AEP-NRC-2013-72
10 CFR 50.54(f)

Donald C. Cook Nuclear Plant Units 1 and 2
Six Month Status Report in Response to March 12, 2012, Commission Order Modifying Licenses
with Regard to Reliable Spent Fuel Pool Instrumentation
(Order Number EA-12-051)

Indiana Michigan Power Company's First Six Month Status Report for the Implementation of Order EA-12-051, Order Modifying Licenses with Regard to Requirements for Reliable Spent Fuel Pool Instrumentation

Figure 1

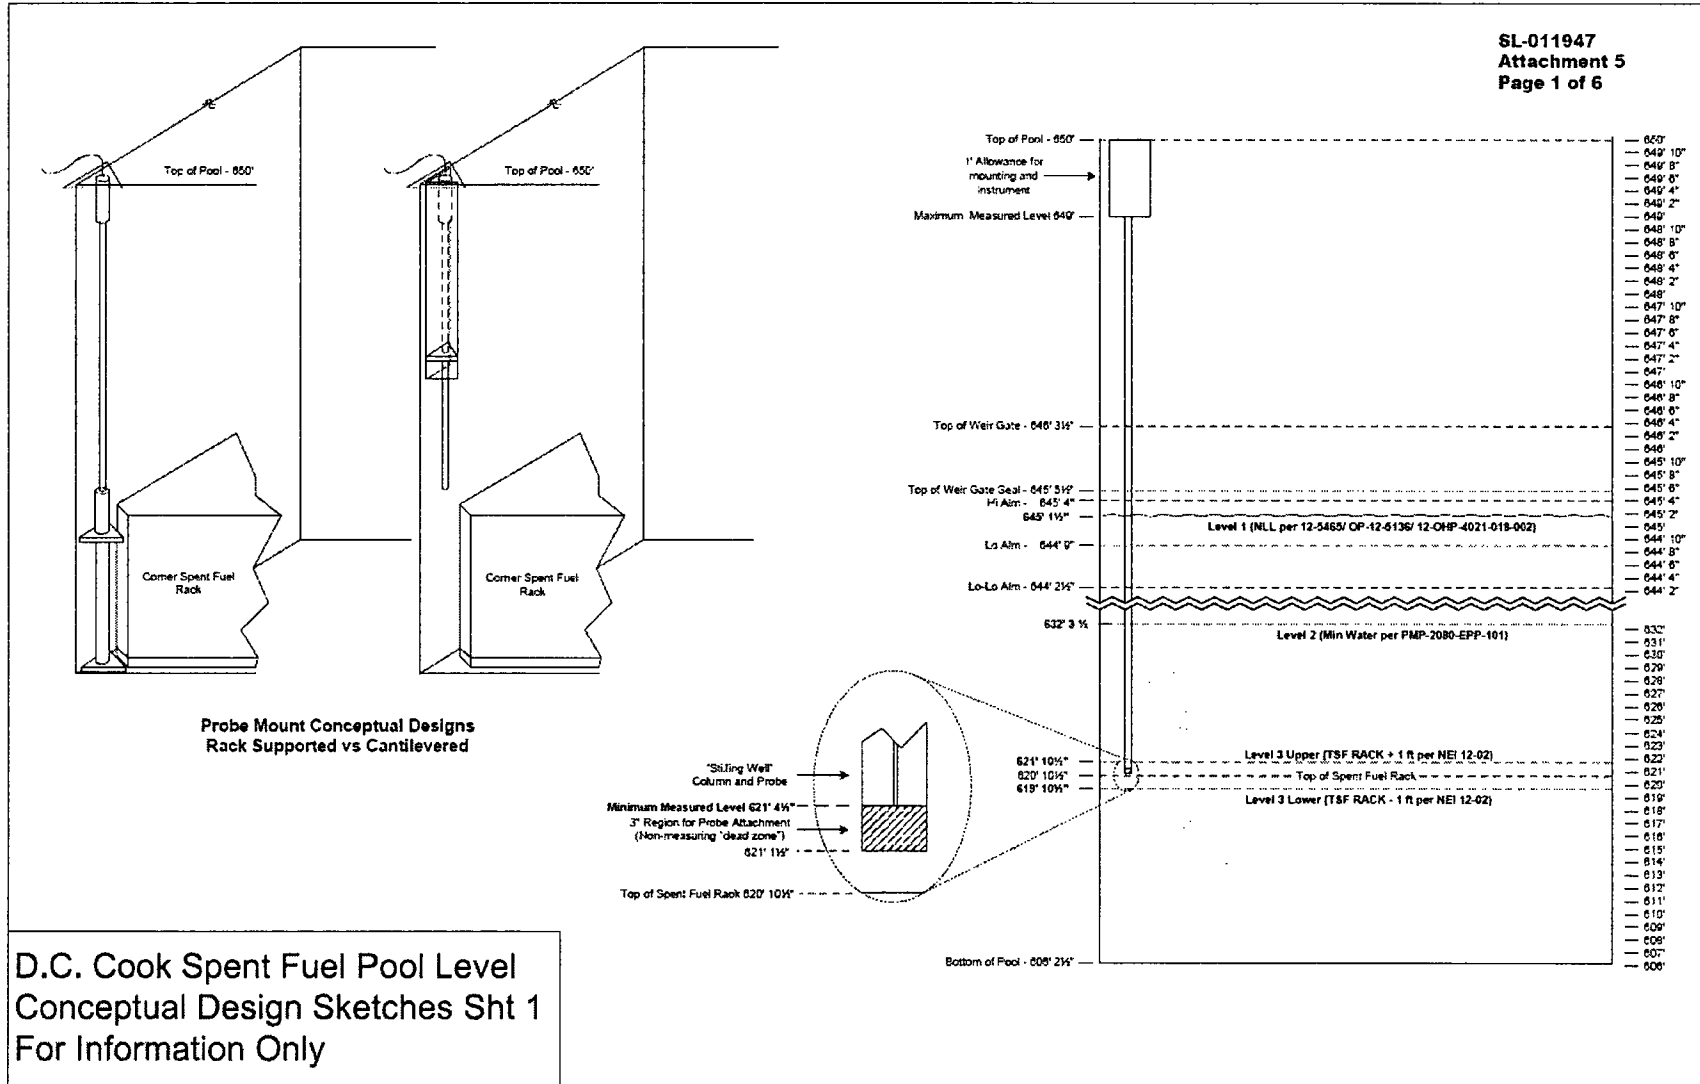
b)	Provide a clearly labeled sketch depicting the elevation view of the proposed typical mounting arrangement for the portions of instrument channel consisting of permanent measurement channel equipment (e.g., fixed level sensors and/or stilling wells, and mounting brackets). Indicate on this sketch the datum values representing Level 1, Level 2, and Level 3, as well as the top of the fuel. Indicate on this sketch the portion of the level sensor measurement range that is sensitive to measurement of the fuel pool level, with respect to the Level 1, Level 2, and Level 3 datum points.	Complete. Sketch attached to this enclosure as Figure 1.
